The Secretary
NSW Department of Planning, Industry and Environment

11 December 2020

I refer to the Department's letter of 27 November 2020 regarding Modification Application DA S29/3/97-Mod-1 for Eastern Creek Karts for modification of the Event Parking Area to 50 Peter Brock Drive, Eastern Creek (Lot 4 DP1079897) in the Blacktown local government area (LGA).

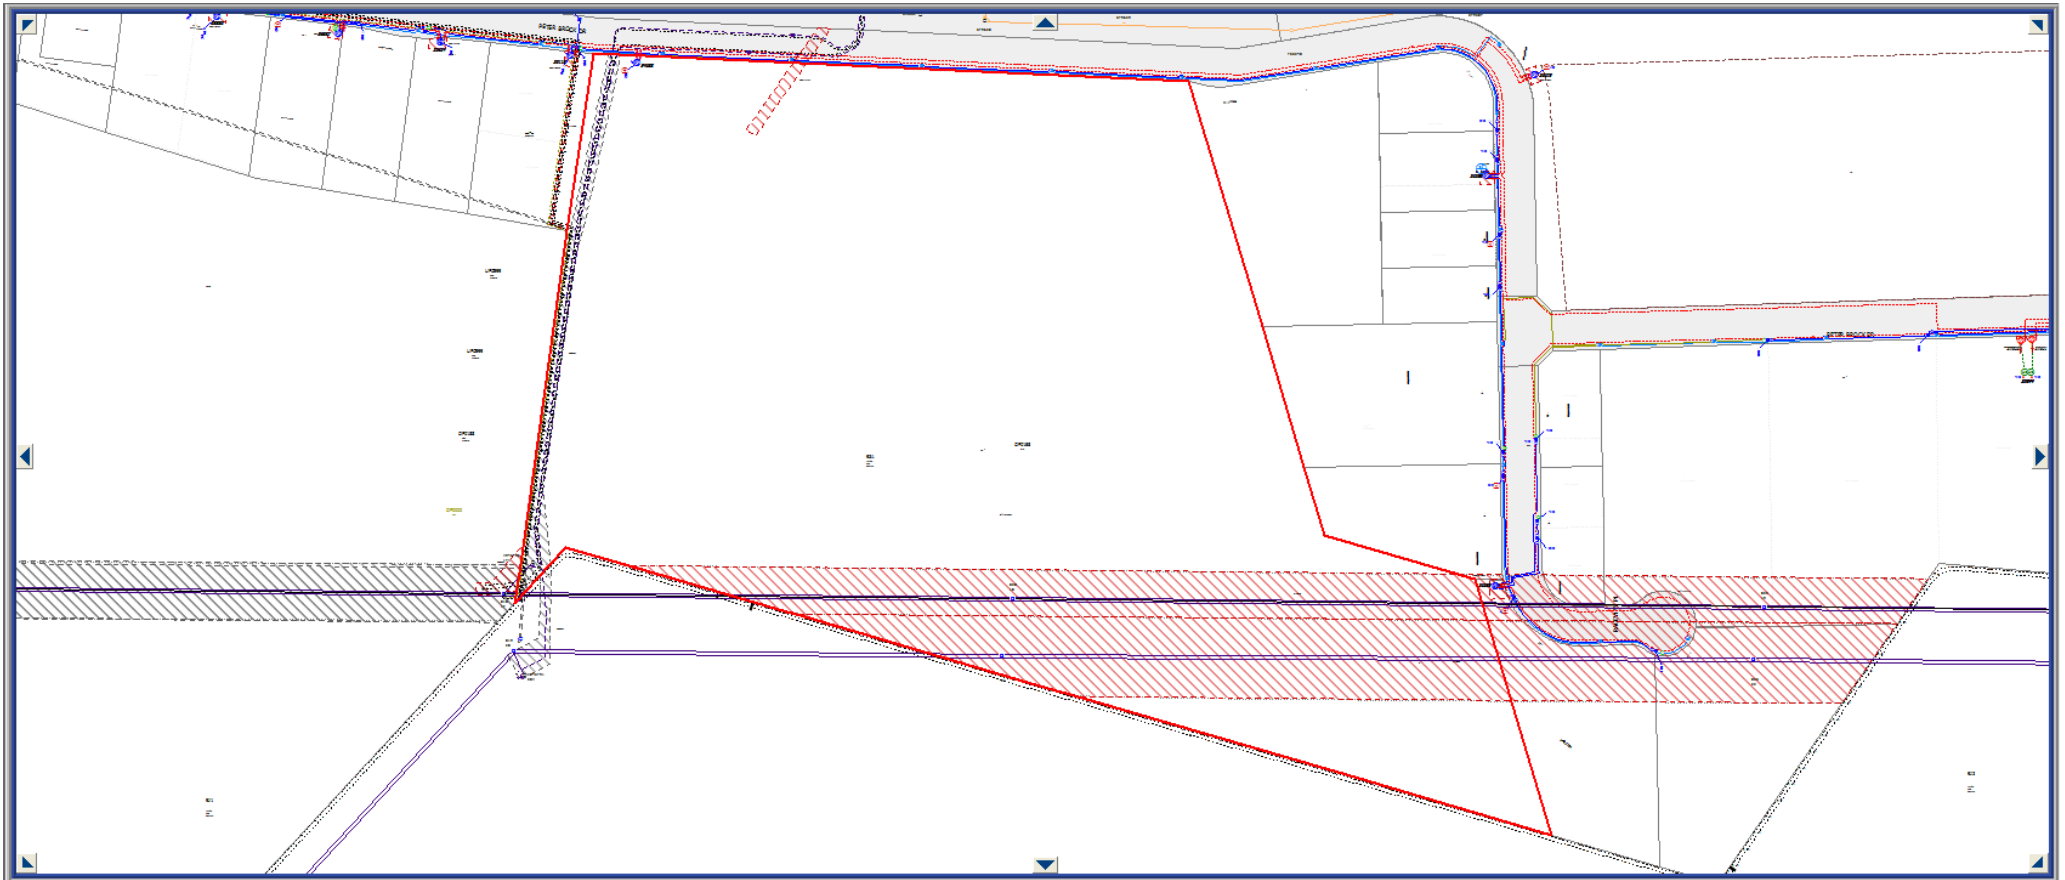
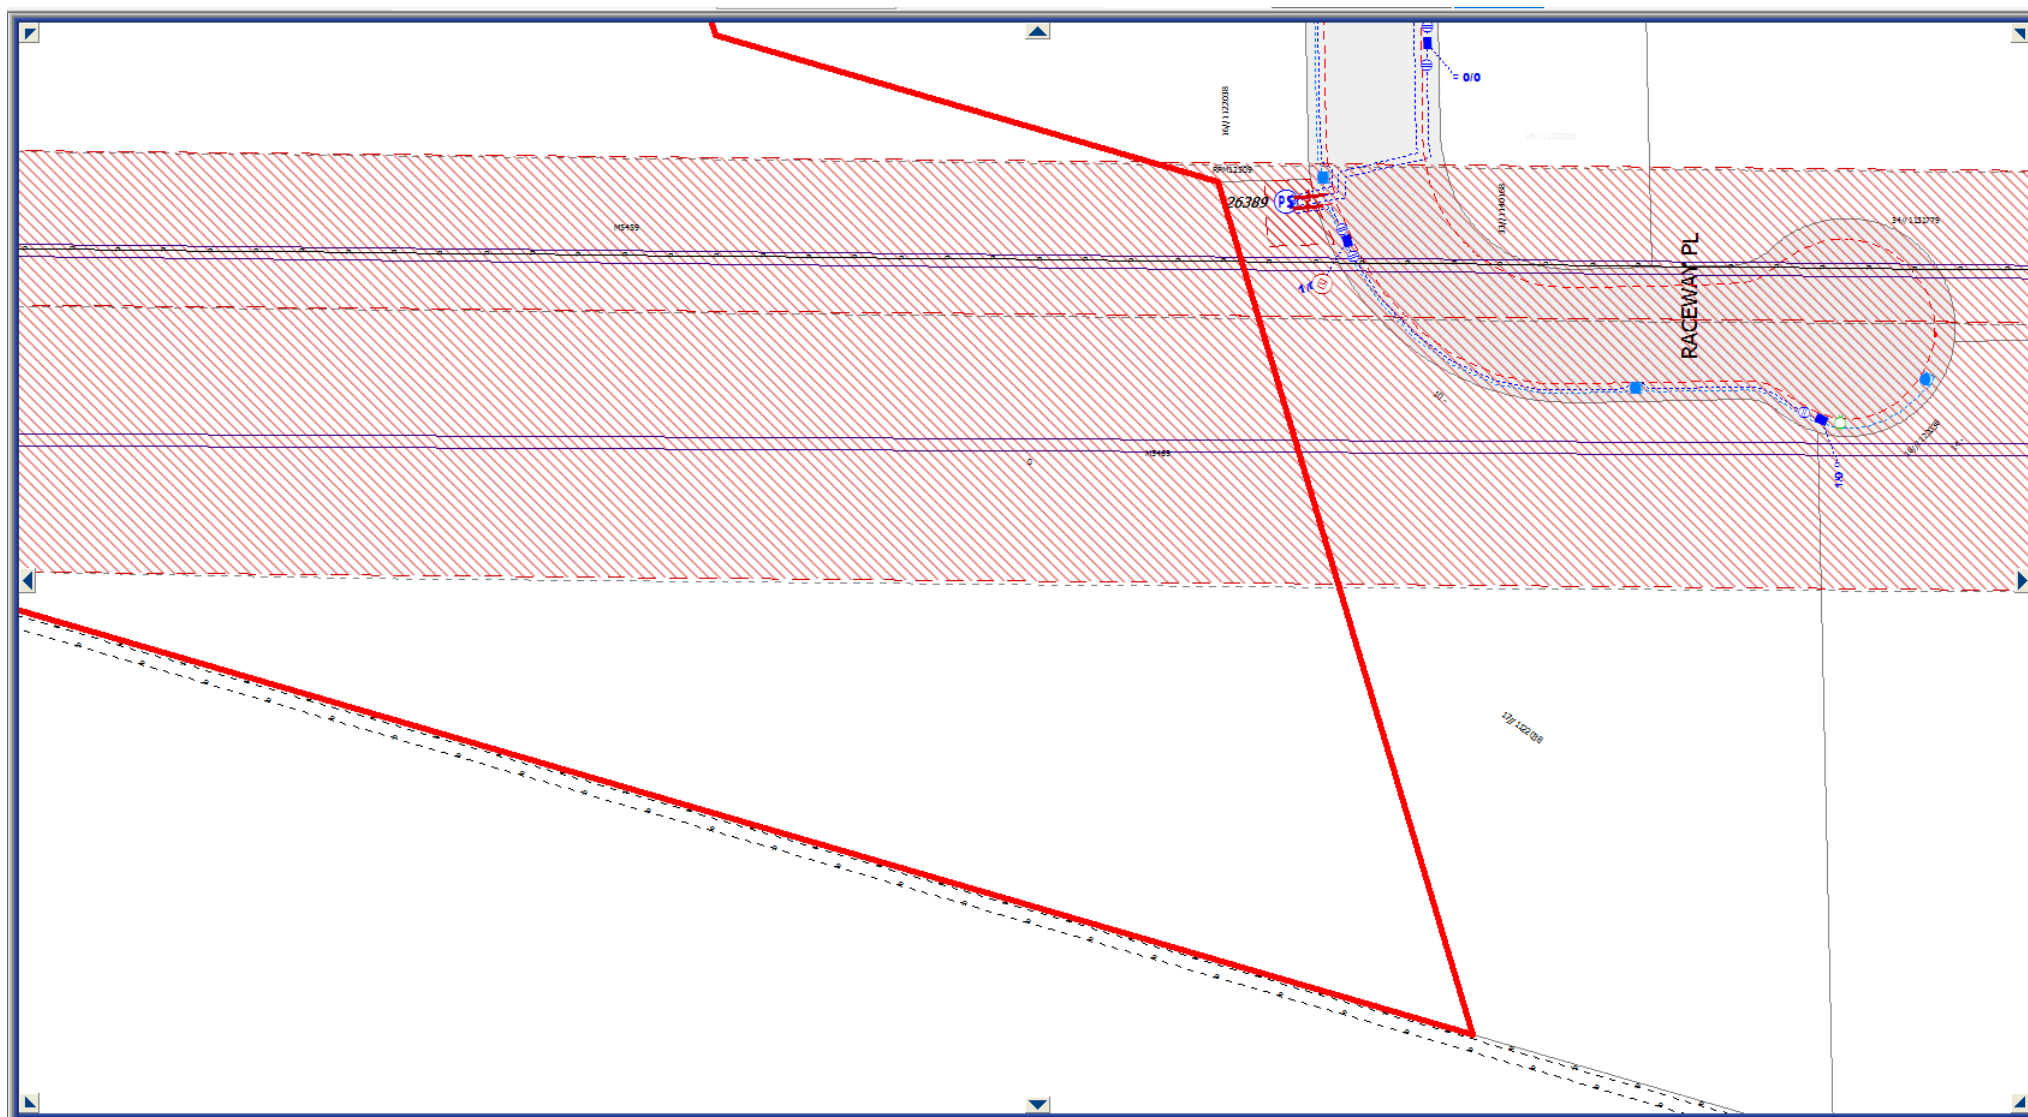
As shown in the below site plans from Endeavour Energy's G/Net master facility model (and extract from Google Maps Street View and SIX Maps) in regard to the proposed works area (outlined in blue on the Site Plan) there is:

- An easement benefitting Endeavour Energy (indicated by red hatching) for 132,000 volt / 132 kilovolt (kV) high voltage overhead power lines and overhead pilot cables (carrying protection signals or communications between substations).
- Adjoins underground pilot cables over Lot 2 DP 1062094 running parallel to the rear southern boundary.
- It is near an easement for padmount substation no. 26389 (indicated by the symbol ) at 10 Raceway Place (Lot 17 DP 1122038)

Figure 1: Aerial view with entire site outlined red. Area of car park in question is outlined blue (Source: SixMaps/City Plan)

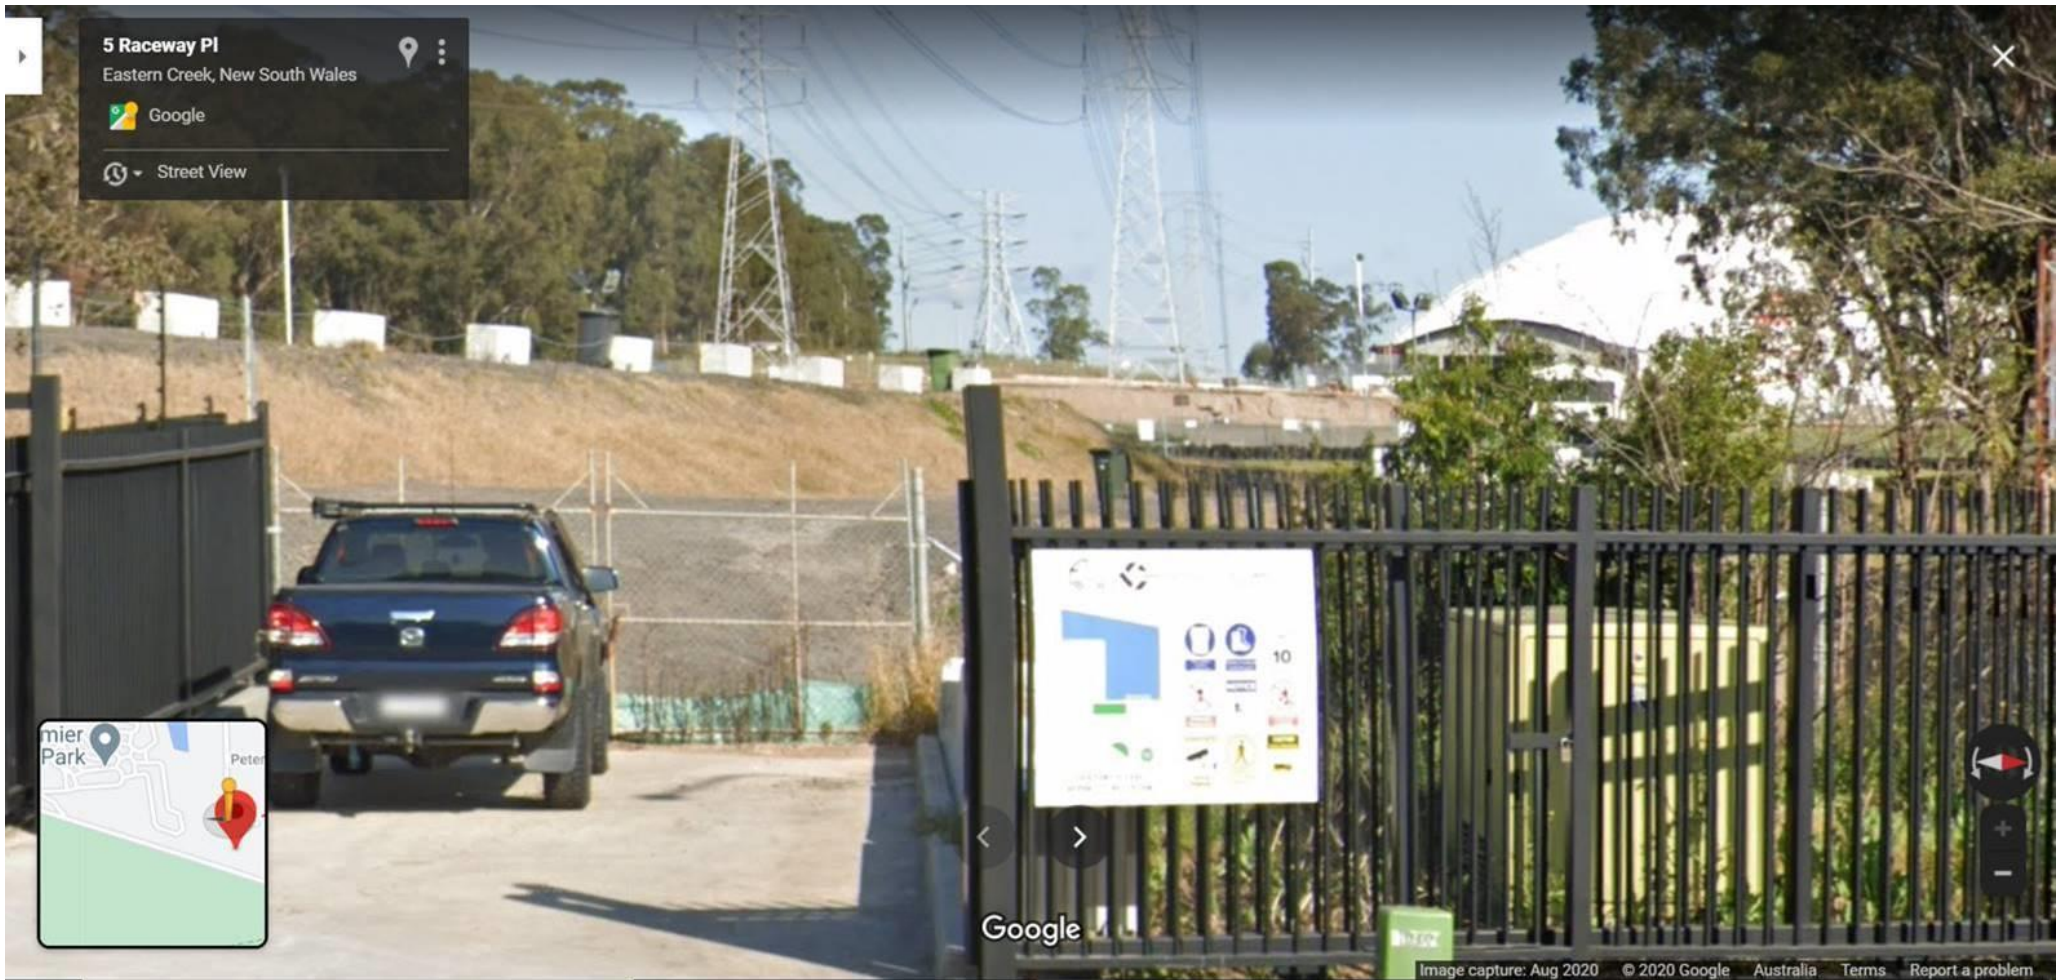
In regard to the increasing the height of the existing ground level, the Report appears to make no mention of the easements for 132 kV overhead power lines which are in 'area of car park in question'. The proposed modifications are in effect the retrospective approval for filling of the car park area which have already been completed.

The Overflow Car Park Plan shows the easement but is only a two dimensional drawing which does not show the effects on the overhead power lines. In January 2019 when Endeavour Energy became aware of the filling it was provided with Richard & Co. Plan of Detail and Levels Over Part Lot 4 in DP 1079897 dated 21/01/2019 Version B Sheets 1 – 5. Following completion of the filling, in October 2019 Endeavour Energy was provided with Richard & Co. Plan of Detail and Levels Over Part Lot 4 in DP 1079897 dated 21/01/2019 Version C Sheets 1 – 5 which indicates 'Carpark Under Construction'. In addition as shown in the following extract of the Stormwater Report there is also a 'Newley (sic) Constructed Swale' partially within the easement for 132 kV overhead power lines.

As it has now been over 12 months, a new survey plan will need to be provided to confirm the final finished levels of the completed carpark and swale including any changes which may result from the proposed modifications subject of this Development Application.
